**AMERICAN FORK CITY
NOTICE OF PUBLIC HEARING
PLANNING COMMISSION REGULAR SESSION
January 18th, 2023
7:00 p.m.**

AMERICAN FORK CITY
PLANNING COMMISSION REGULAR SESSION

Review and action on a Site Plan application for wall mounted antennas for Dish Wireless, located at 95 N 200 E, in the Central Commercial (CC-1) Zone.

SHEET NUMBER
T-1

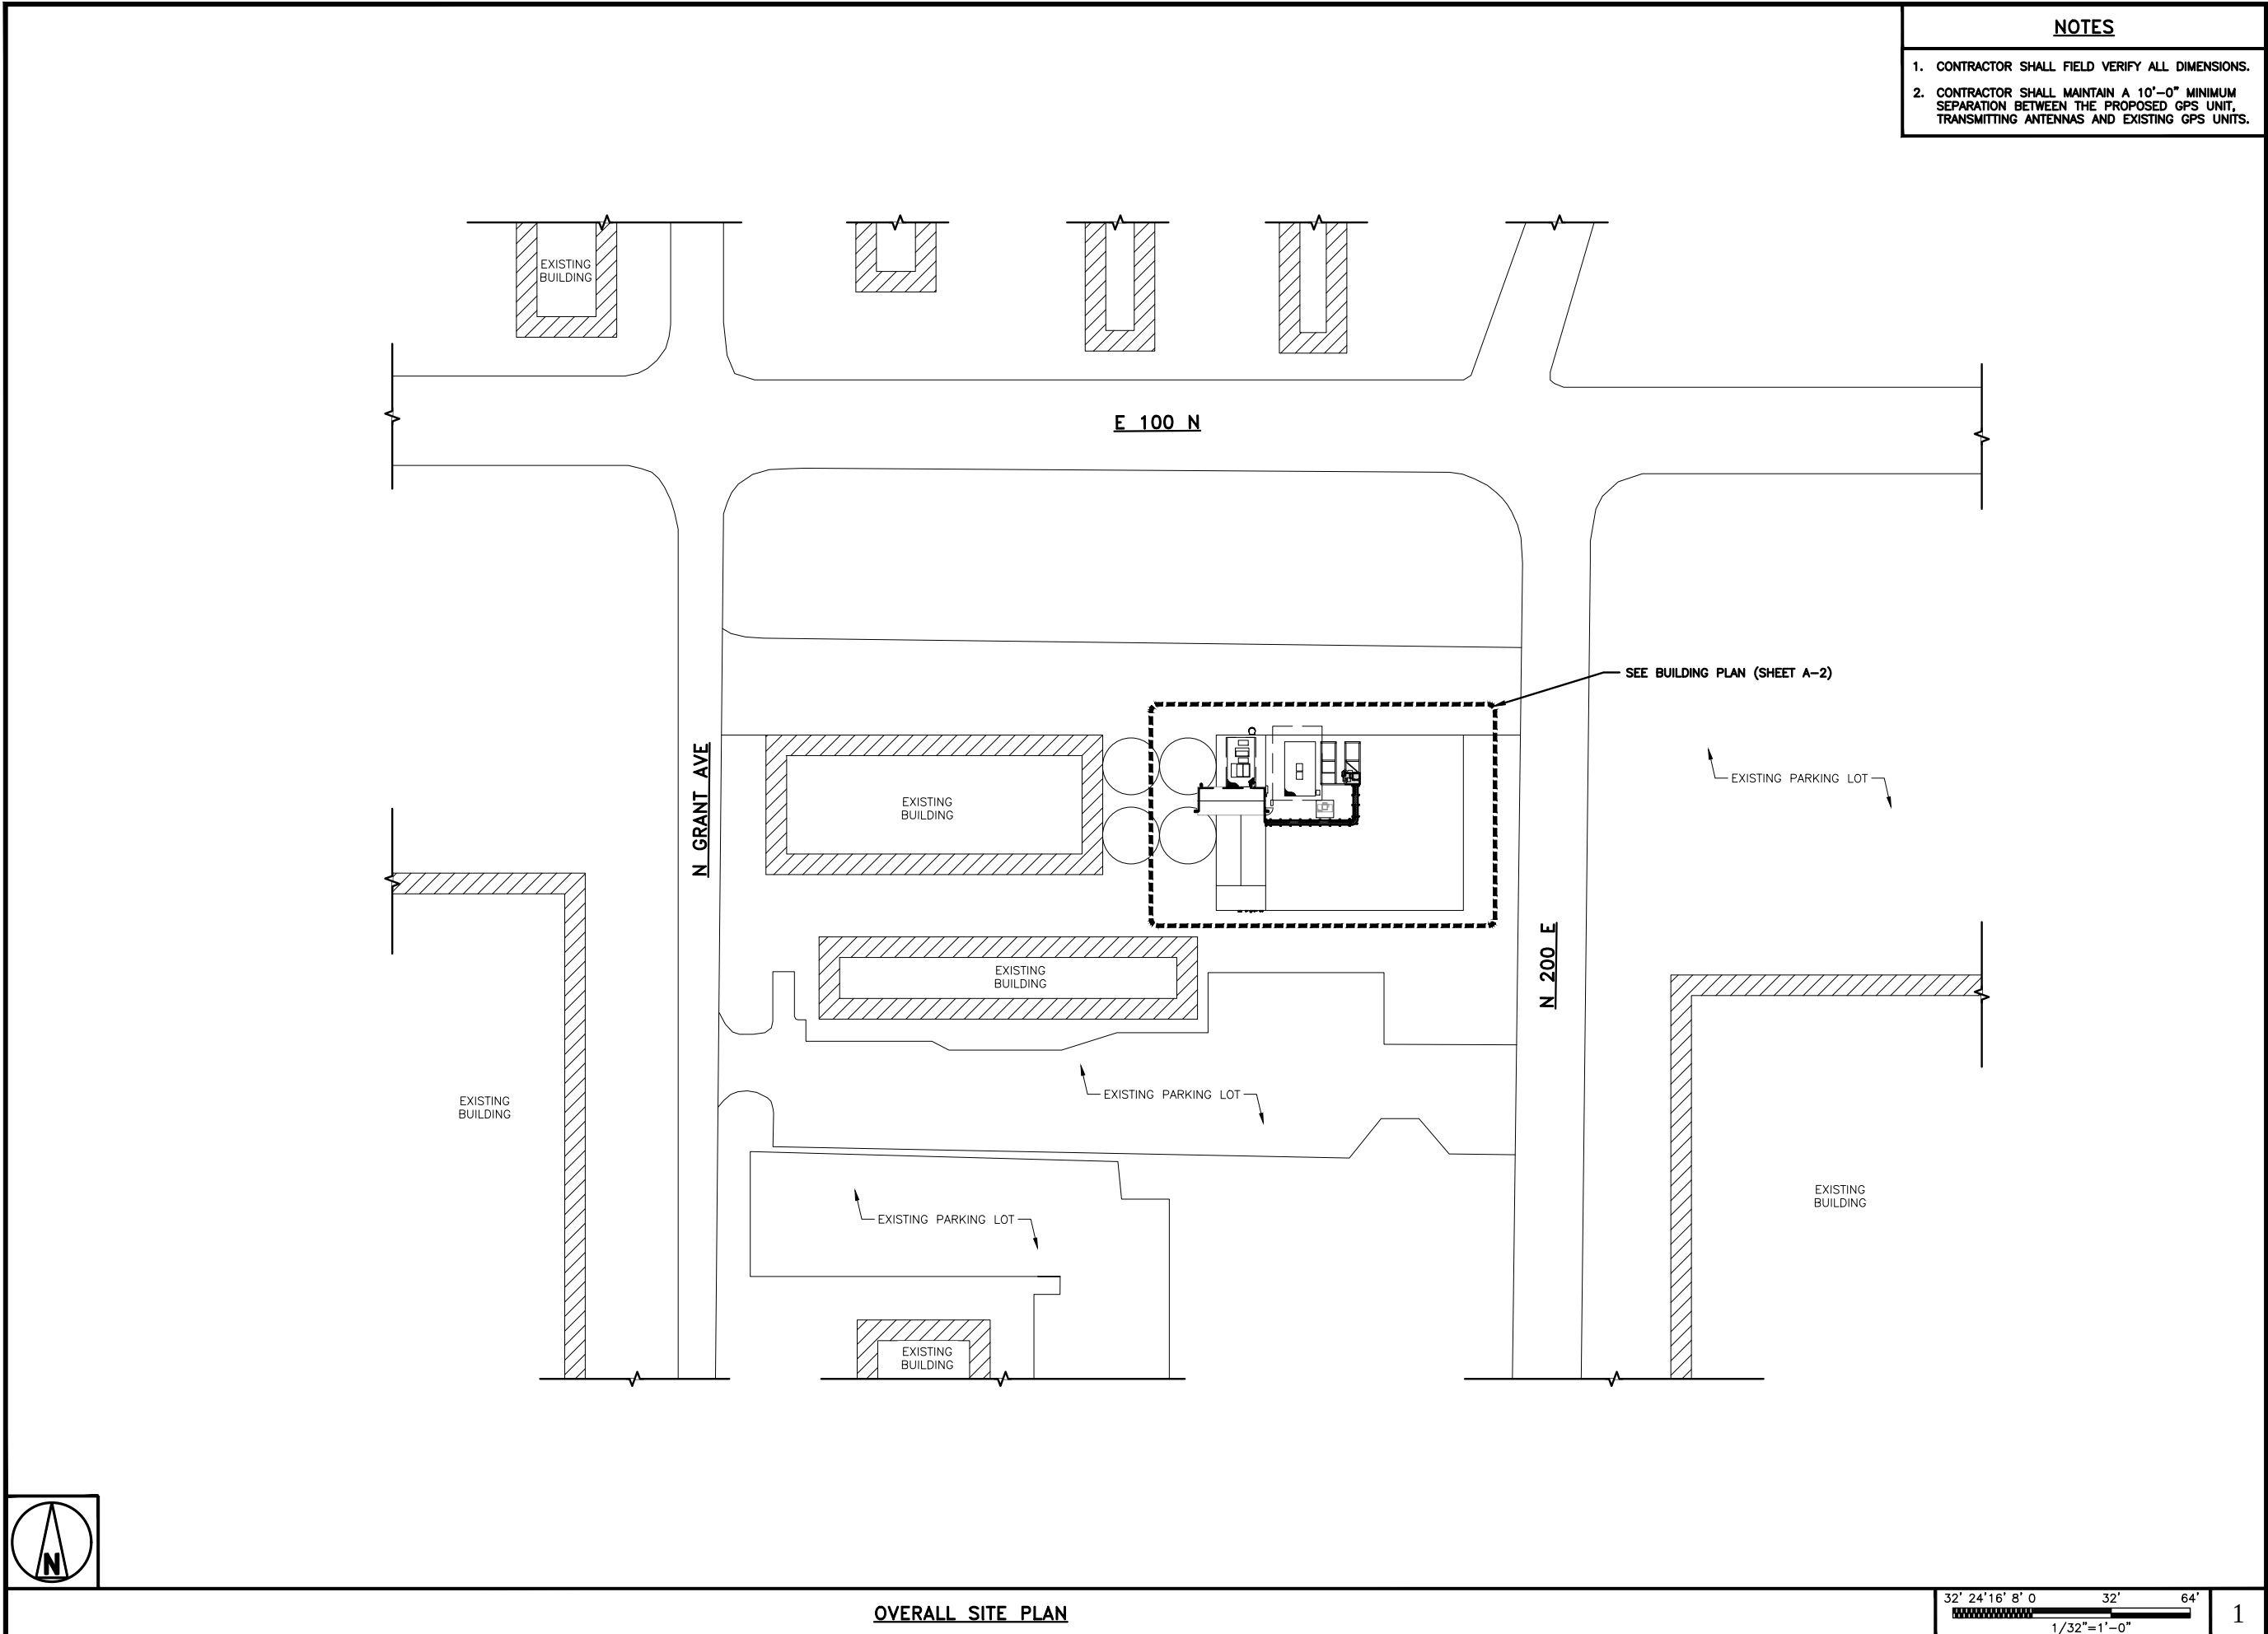
1. Provide appropriate labeling for power disconnect switches/breaker, shown on page A-2 of the plans.

S-1

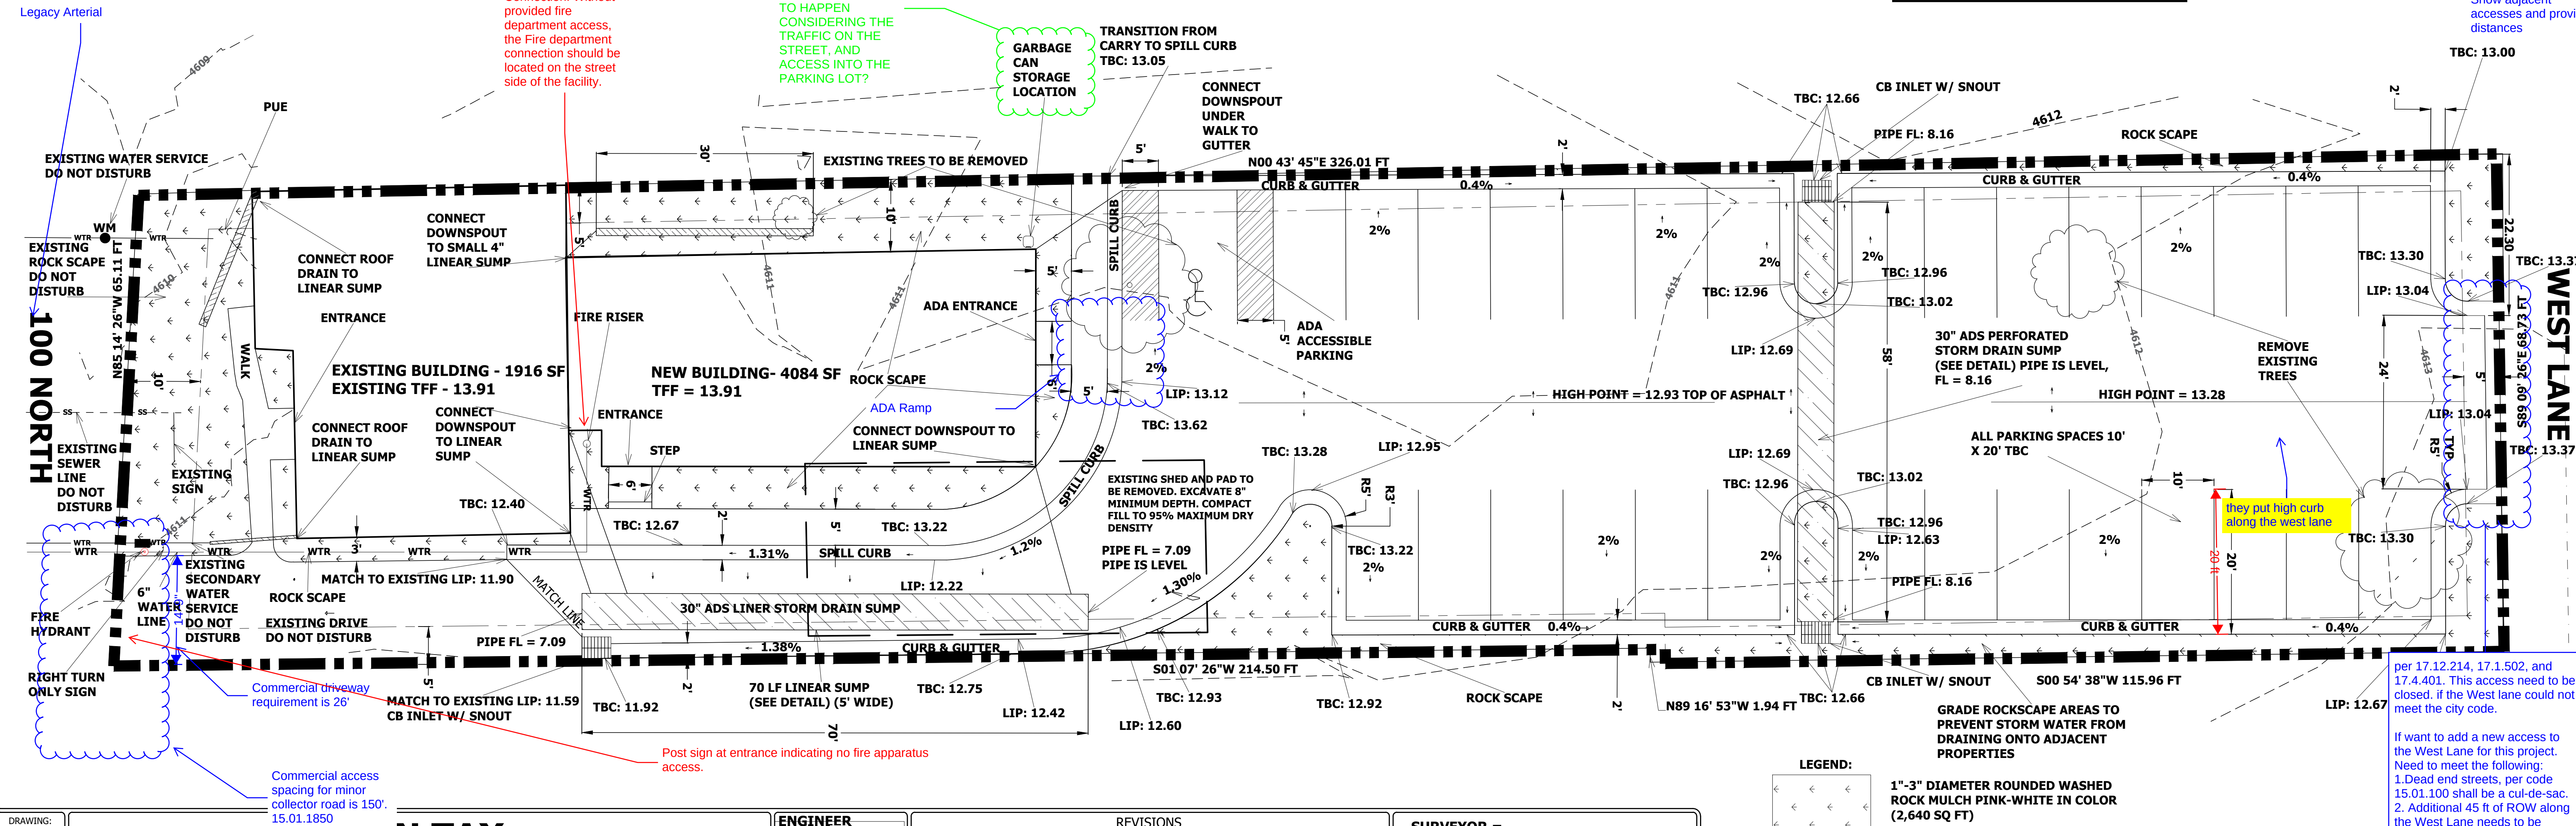
Show adjacent accesses and provide distances

per 17.12.214, 17.1.502, and 17.4.401. This access need to be closed. if the West lane could not meet the city code.

If want to add a new access to the West Lane for this project. Need to meet the following:
1. Dead end streets, per code 15.01.100 shall be a cul-de-sac.
2. Additional 45 ft of ROW along the West Lane needs to be provide
